ADDENDUM #3

Will County Health Department
BID PACKAGE #2 – Misc. Steel/Structural/Enclosure
November 8, 2018

**SECTION 00 91 06
BP #2 - ADDENDUM NUMBER 3**

PROJECT: **WILL COUNTY HEALTH DEPARTMENT - NEW HEALTH DEPARTMENT
BUILDING
501 ELLA AVENUE
JOLIET, ILLINOIS 60433**

PARTIAL SECOND FLOOR SLAB & LINTEL PLAN - AREA 'A'

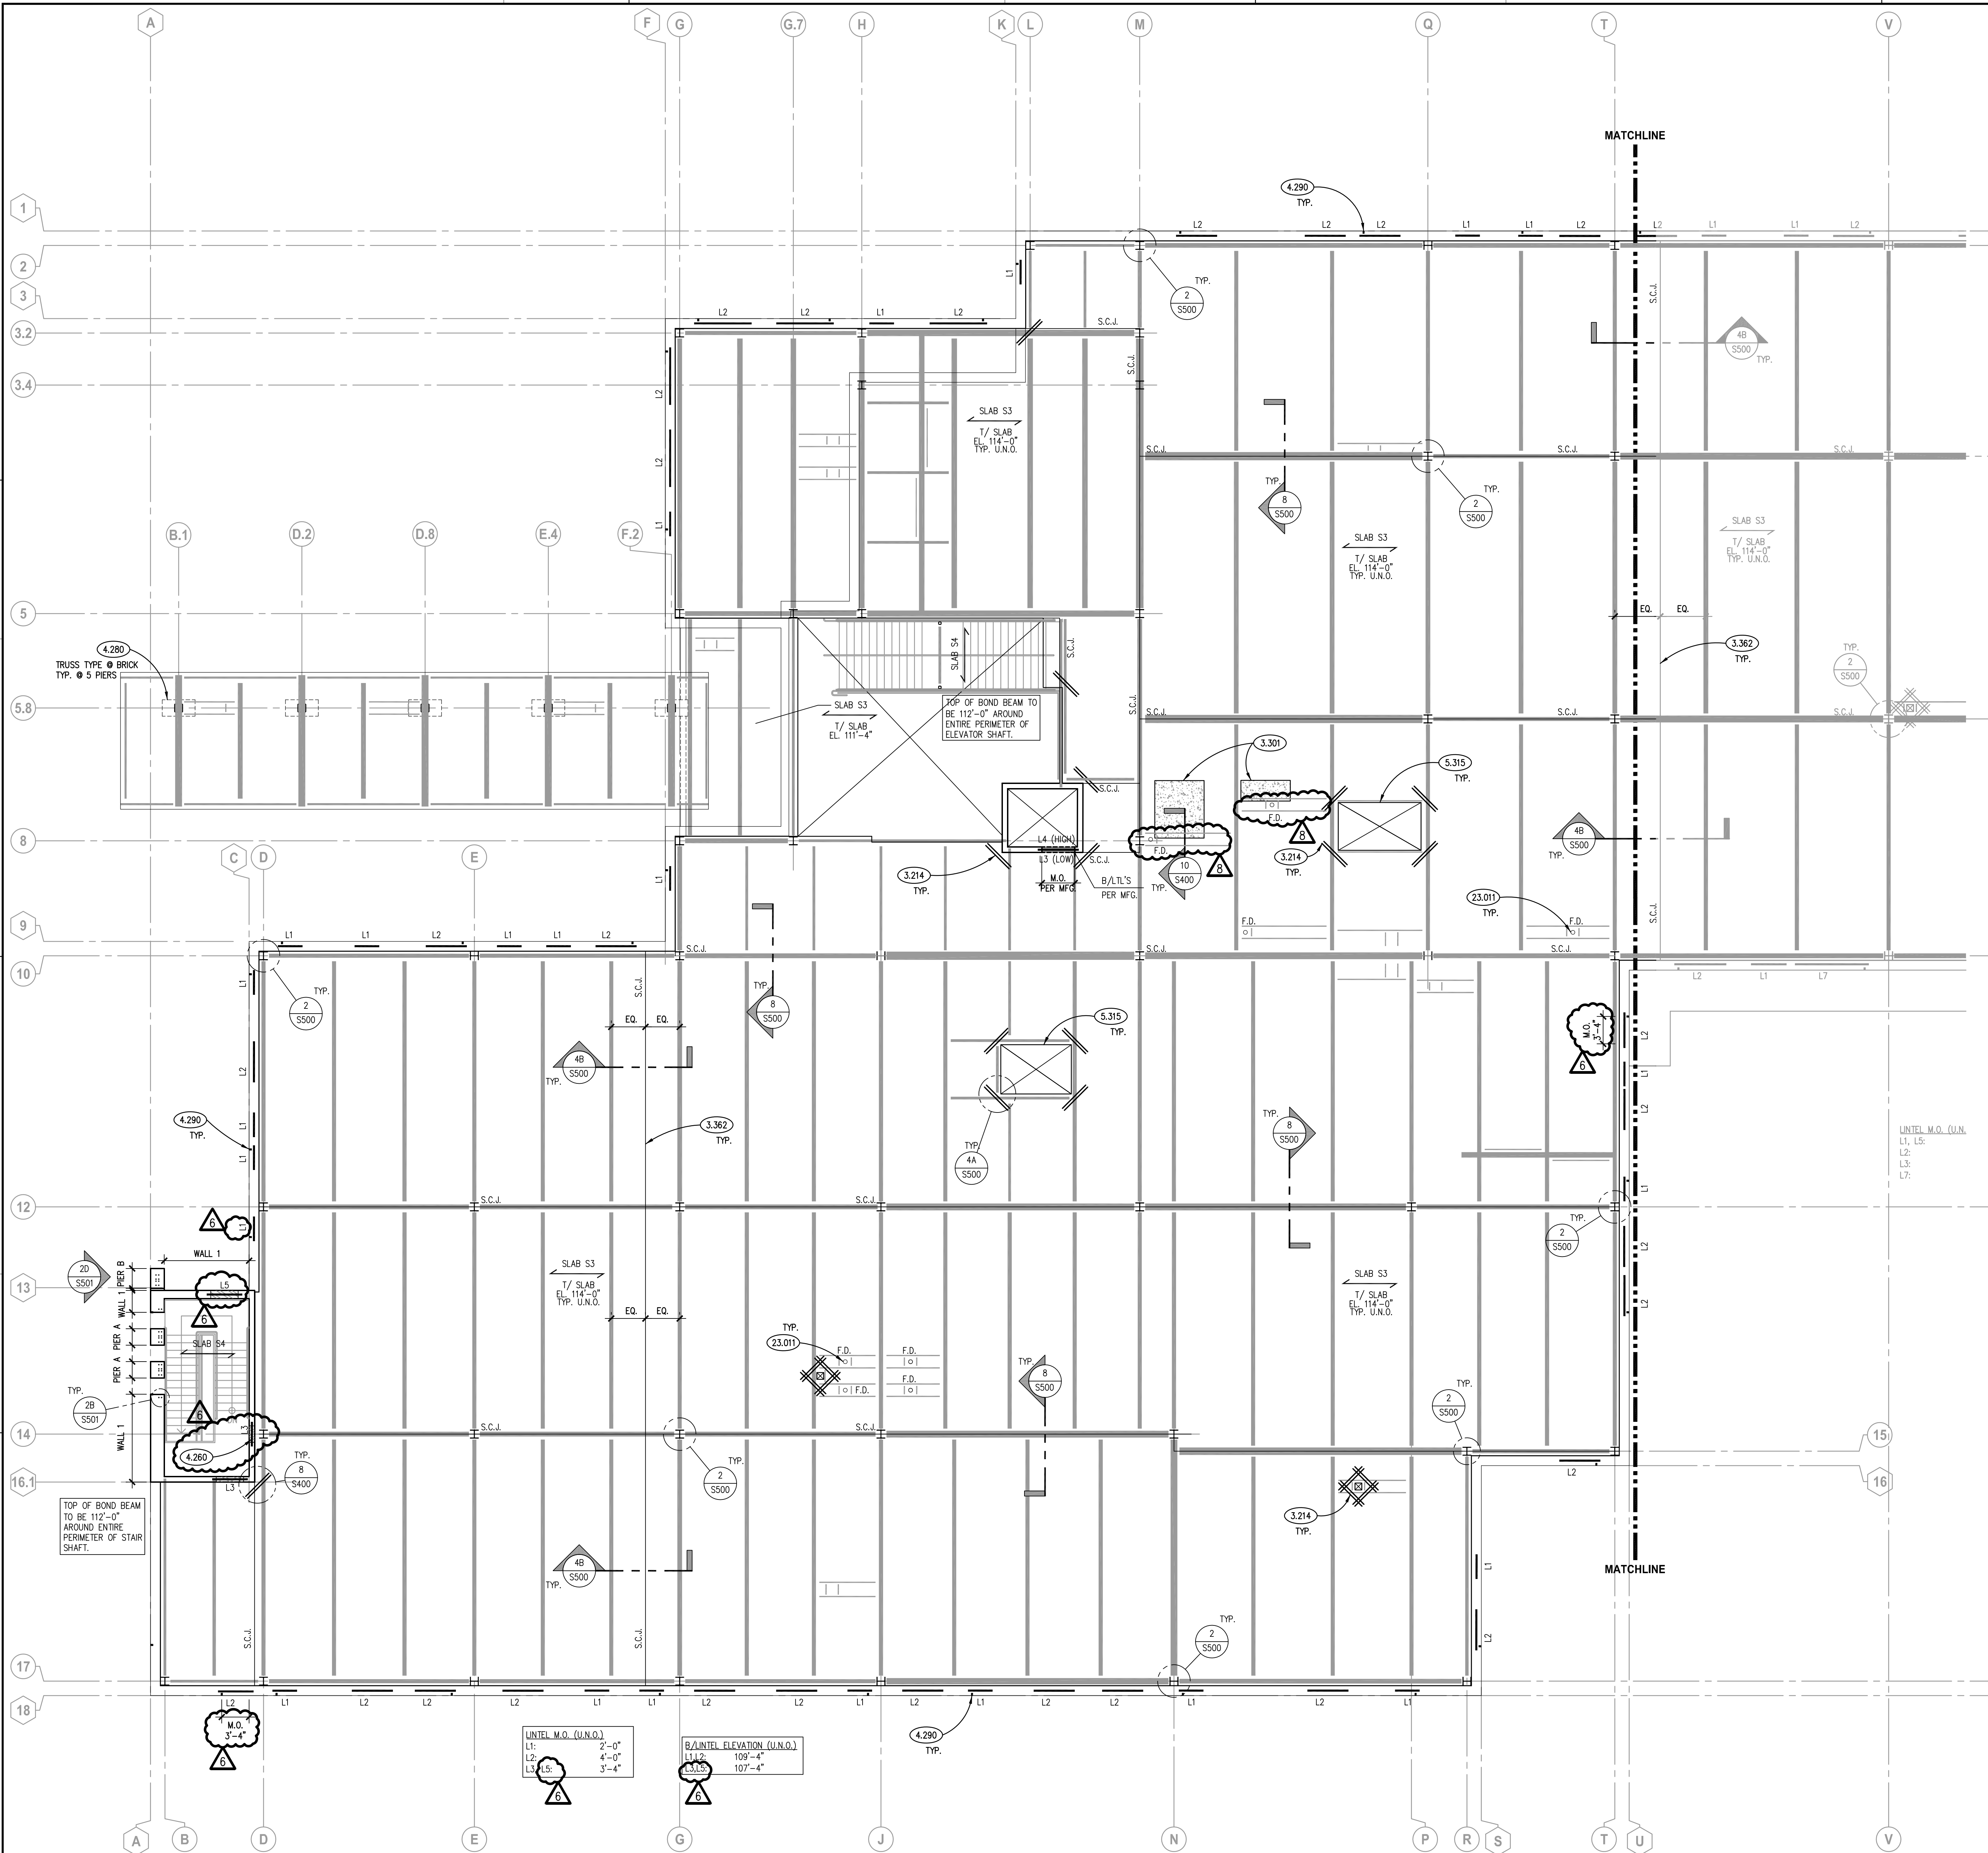
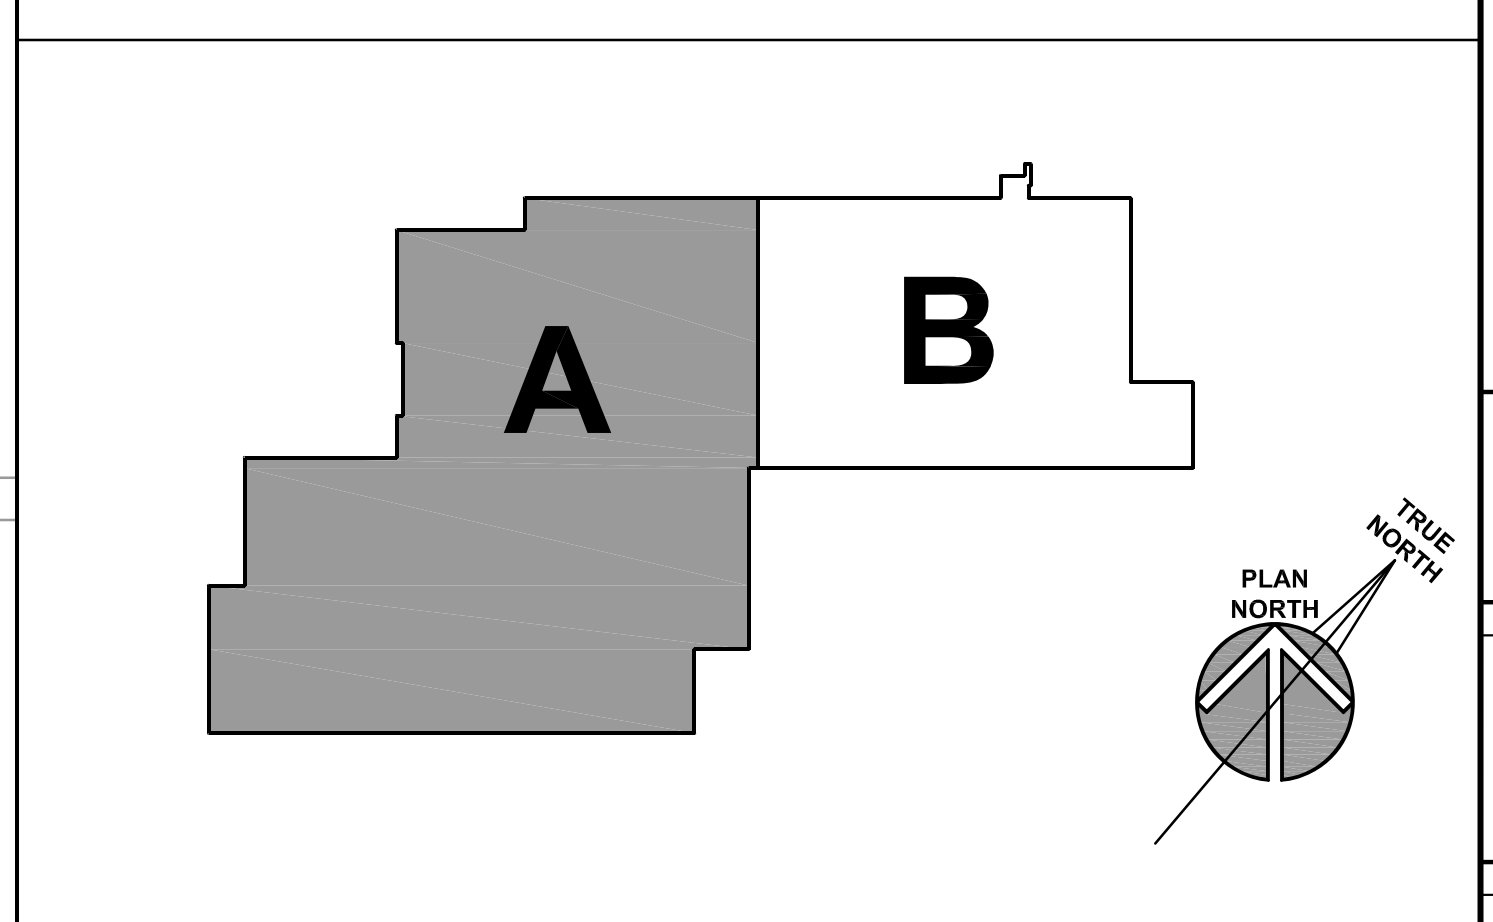
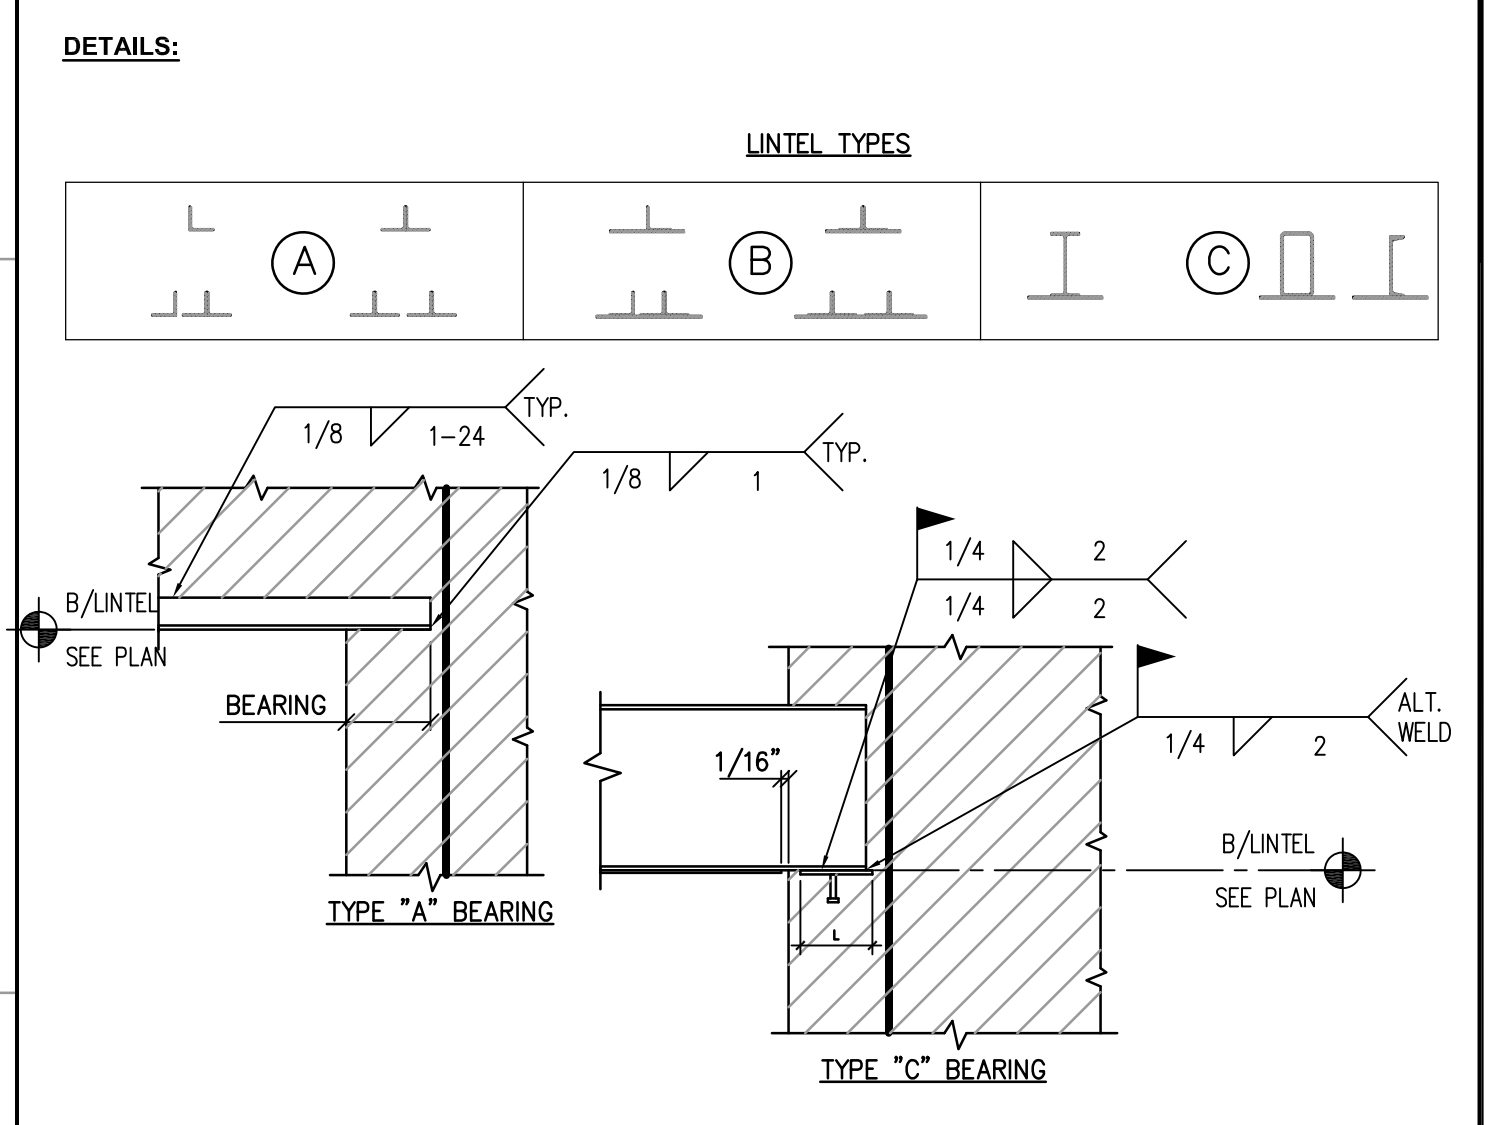
2.03 DRAWING S321S - PARTIAL SECOND FLOOR SLAB & LINTEL PLAN - AREA 'A'

- A. Delete drawing in its entirety and replace with drawing number S321S (attached). Refer to revision cloud 8 for specific changes.
